Safety Recall: 26V337
May 2026

IMPORTANT SAFETY RECALL

Alliance RV has determined that certain 2025 – 2027 Paradigm units equipped with CURT Touring Coil Suspension systems may contain shock retaining bolts that were improperly tightened during production of the suspension assembly. Under certain operating conditions, the retaining bolt head may fracture which could allow the retaining washer and/or bolt head to detach from the vehicle and become road debris, increasing the risk of a crash.

Fig. 1

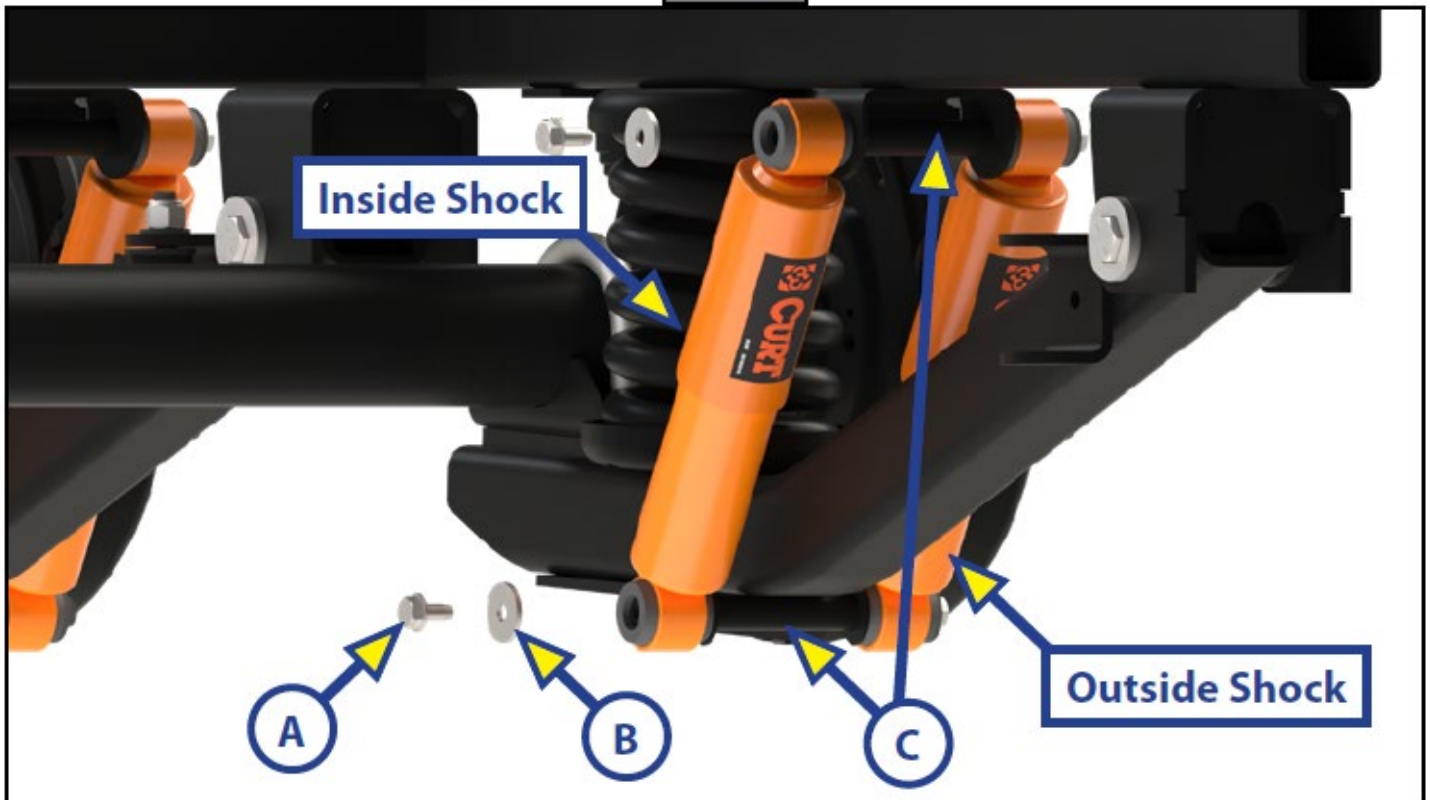
1. Starting with the inside shocks, loosen and remove the two existing 3/8"-16 x 3/4" thread forming screws (Fig. 1A) and washers (Fig. 1B) securing each shock absorber onto its posts (Fig. 1C). Retain washers (PN 249853) for reinstallation in Step 2.

2. Reinstall previously-removed washers onto two new 3/8" - 16 x 3/4" Grade 8 hex head bolts.

Fig. 2

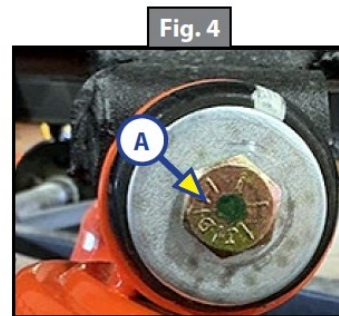
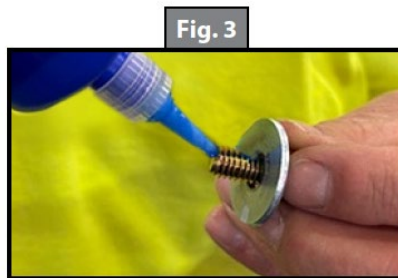
NOTE: Some kits will come with bolts pre-coated with thread locker instead of 0.02oz capsules of Loctite. If the bolts are pre-coated (Fig.2), skip step 3.

3. Apply two threads of thread locker to the Grade 8 bolt threads (Fig 2).
4. Install new bolt assemblies by hand for a minimum of three full threads (or three turns) before proceeding to step 5.
5. Torque new Grade 8 bolts to 20-30 ft-lbs. Do not over torque bolts.
6. Repeat procedure on all other inside and outside shock absorber bolts.
